# SITE PLAN

Address: 11556 Highway 94  
Colorado Springs, CO, 80929

# Site Plan\_v3\_redlines.pdf Markup Summary

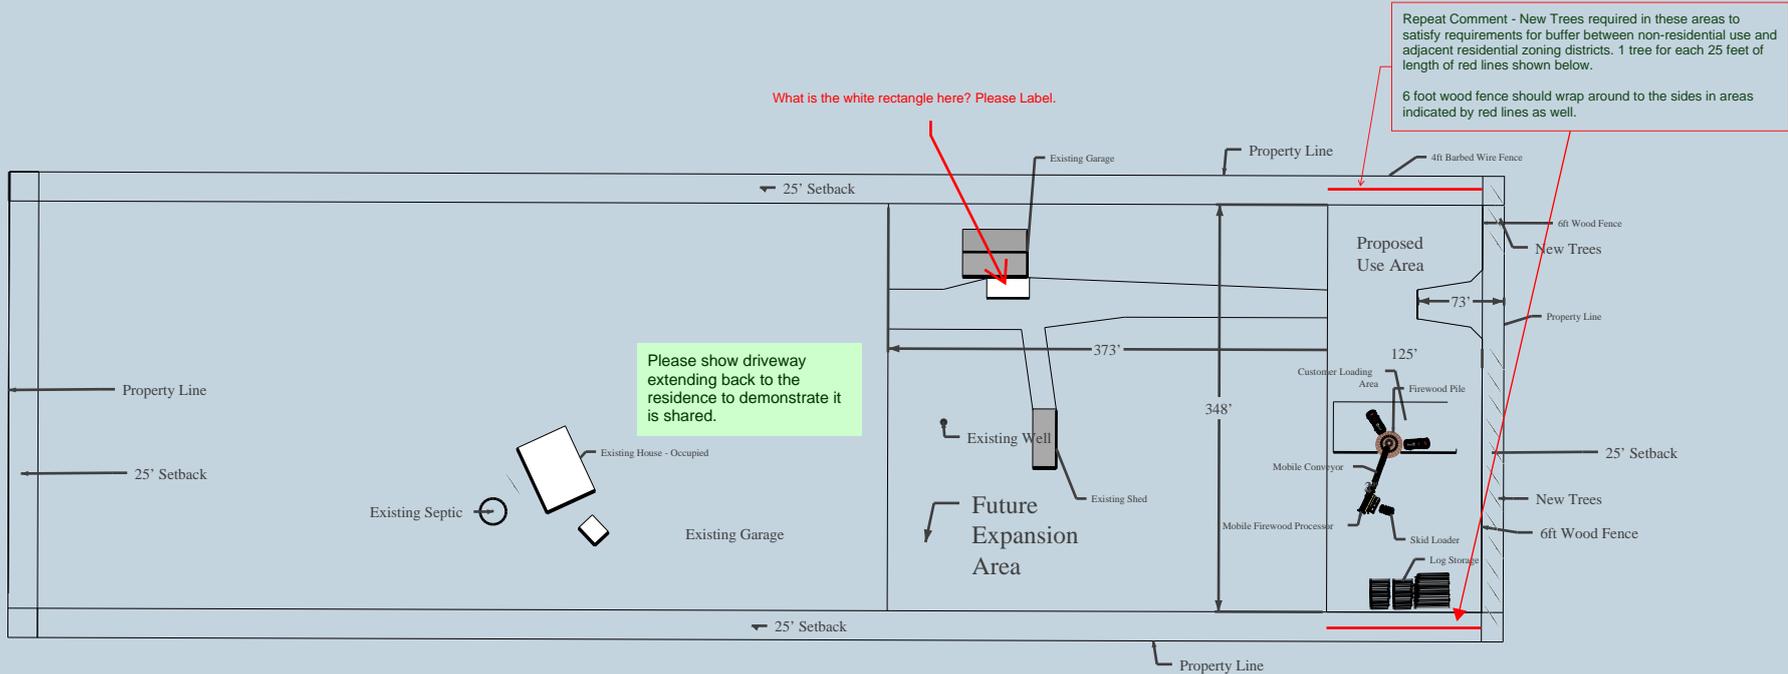
Repeat Comment - New Trees required in these areas to satisfy requirements for buffer between non-residential use and adjacent residential zoning districts. 1 tree for each 25 feet of length of red lines shown below.

6 foot wood fence should wrap around to the sides in areas indicated by red lines as well.

What is the white rectangle here? Please Label.

Please show driveway extending back to the residence to demonstrate it is shared.
